# SERVICE PARTS LIST

**BULLETIN NO.**  
**54-26-1725**

SPECIFY CATALOG NO. AND SERIAL NO. WHEN ORDERING PARTS		REVISED BULLETIN	DATE
<b>1/2" D.I. IMPACT WRENCH</b>			July 2002
CATALOG NO.	9071-20	STARTING SERIAL NO.	230A
		WIRING INSTRUCTION <b>58-01-1820</b>

# RECALL NOTICE!

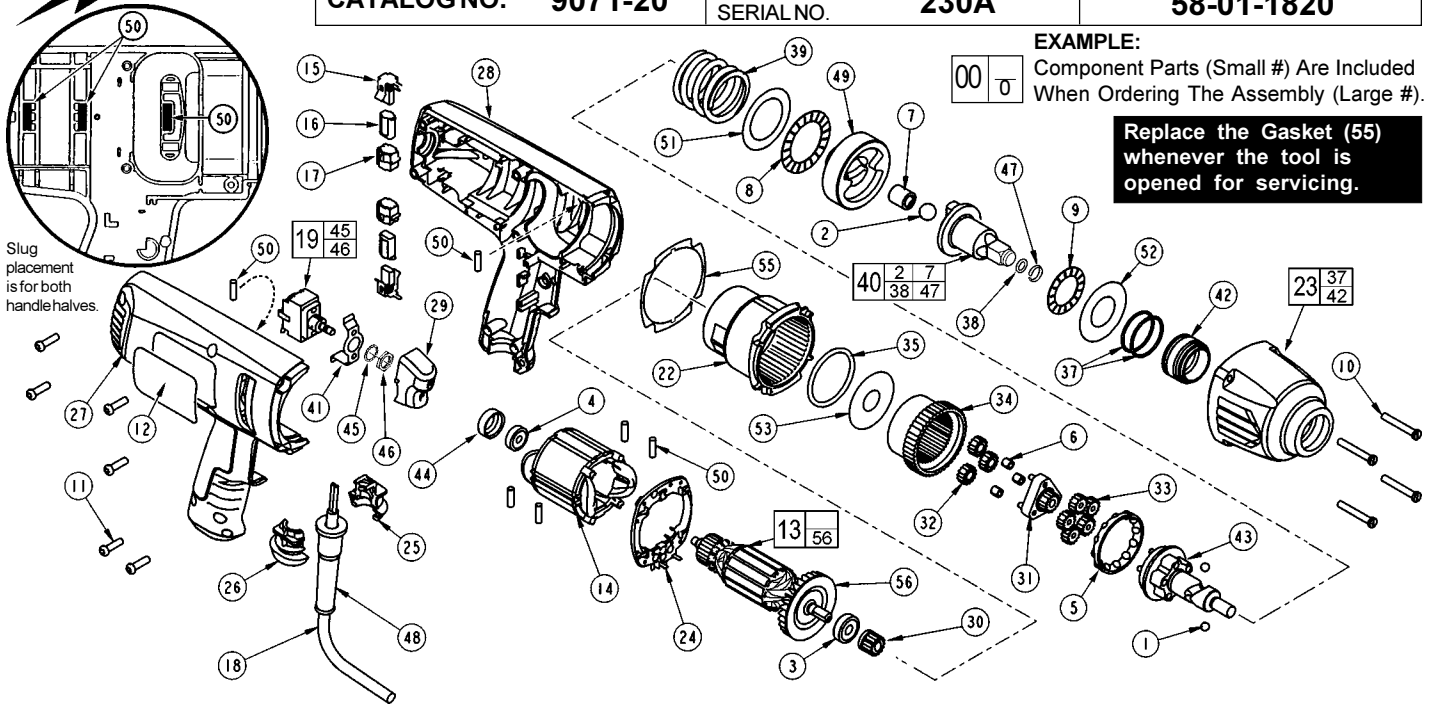
Milwaukee is providing a **no-charge** warranty service to owners of **9070-20, 9071-20, and 9075-20 Impact Wrenches**. We are taking this action because under certain circumstances the cord set of the Impact Wrench may pull out of the handle, which poses a risk of injury or electrocution.

For operator safety a **9070-20, 9071-20 or 9075-20 Impact Wrench** within the listed serial number ranges **require original equipment 31-17-0265 Cord Clamp to be replaced with a 31-17-0270 Cord Clamp.**

As an aid to determining the cord clamp in a tool, the 31-17-0270 Cord Clamp has the numbers **'0270'** molded into the clamping rib. The 31-17-0265 Cord Clamp has no markings on the rib.

If the tool contains a 31-17-0265 Cord Clamp, please return your Impact Wrench to the nearest Milwaukee **factory** Service Center or Authorized Service station for no-charge warranty replacement of the cord clamp.

If nameplate has a **'X'** stamped into the tool's nameplate, next to the catalog number, the tool has been repaired and the defective cord clamp has already been replaced.
